MANDATORY SERVICE BULLETIN

IS-28B2/EO-6

Approved by	:	Department of Civil Aviation with no. 345 / 8.01.1979
Product	:	IS-28B2 glider.
Object	:	Fixing the front seat back rod.
Compliance	:	Revision Record Card no.540, 662.

DATE: 04.01.1979

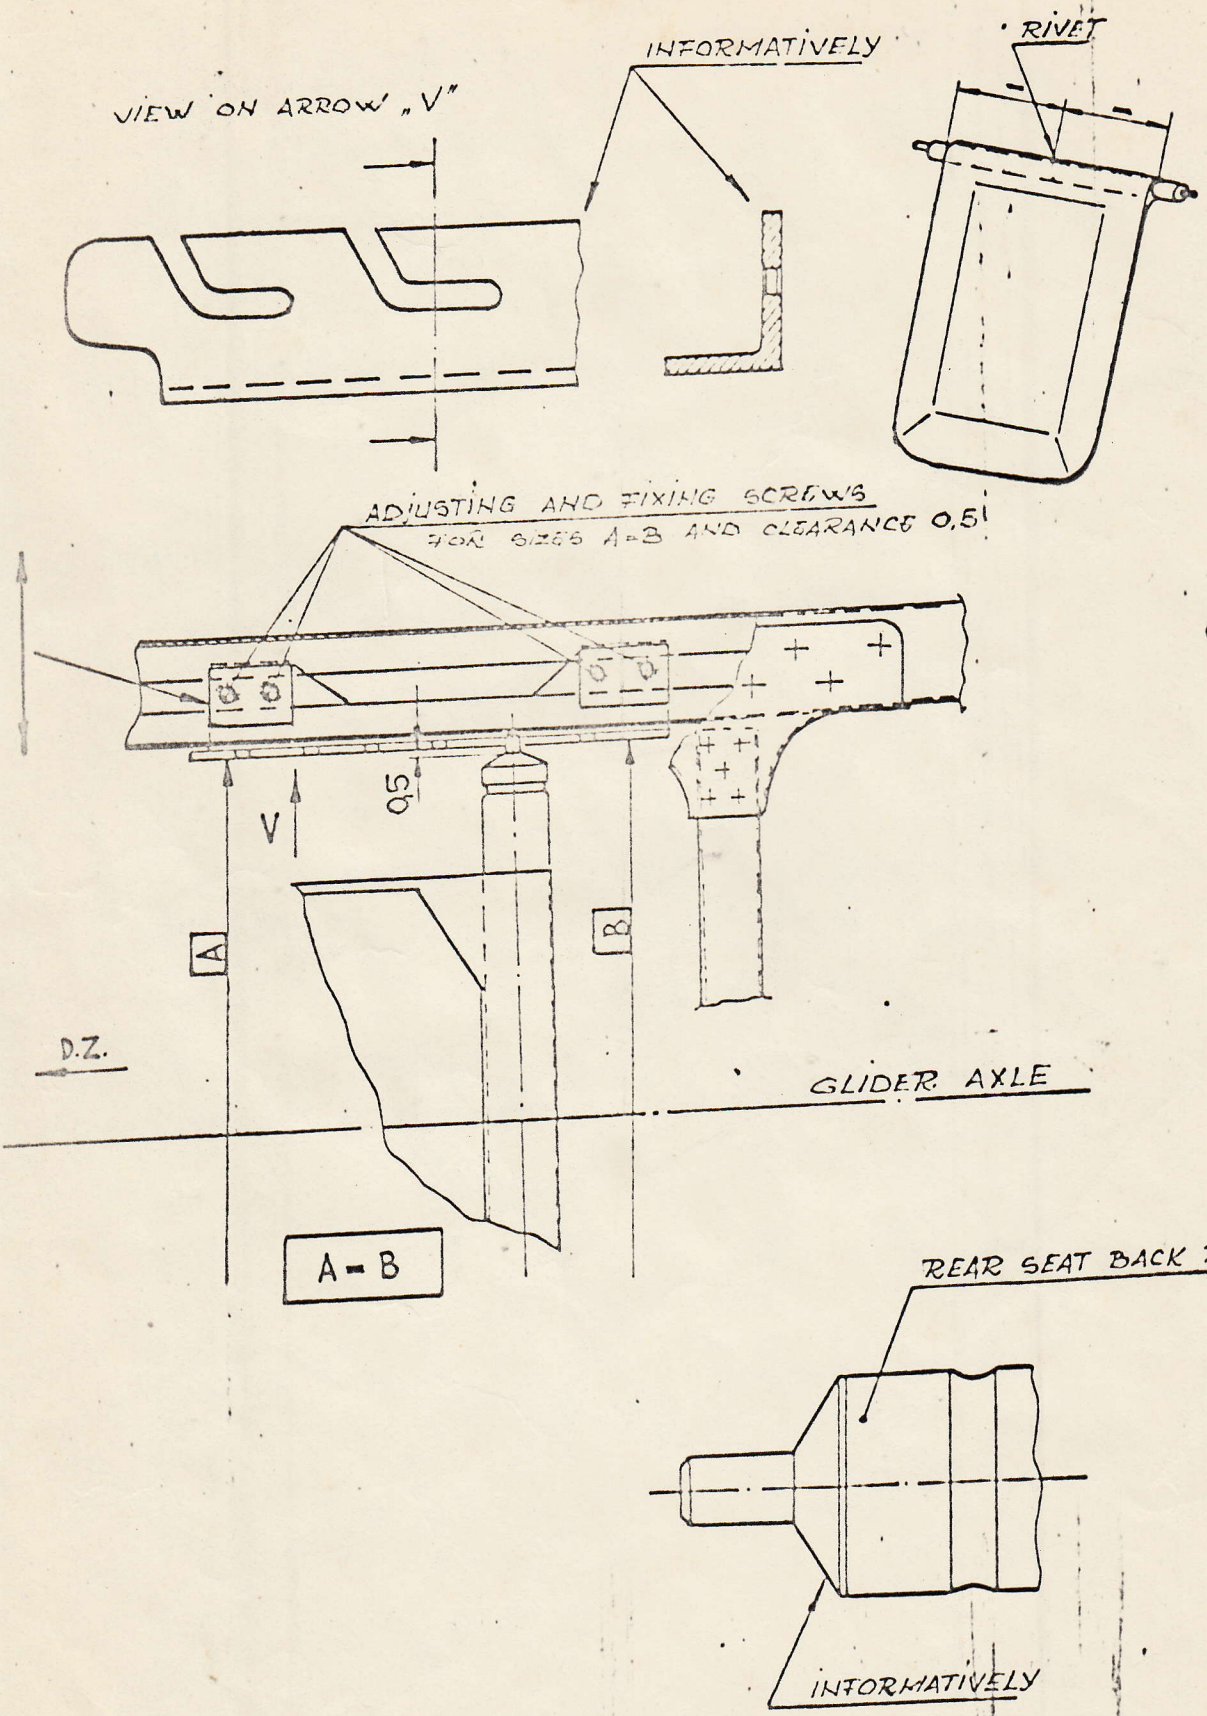
1. Fixing the front seat back with rivet
2. Checking and adjusting the front seat back rod clearance according to Appendix I.

1. Fixing the front seat back with rivet according to Appendix I.
2. Checking and adjusting the front seat back rod clearance according to the indications in Appendix I.

INFORMATIVELY
RIVET
VIEW ON ARROW „V"
ADJUSTING AND FIXING SCREWS
FOR SIZES A-B AND CLEARANCE 0,5
V
95
A
B
D.Z.
GLIDER AXLE
A - B
REAR SEAT BACK ROD
INFORMATIVELY
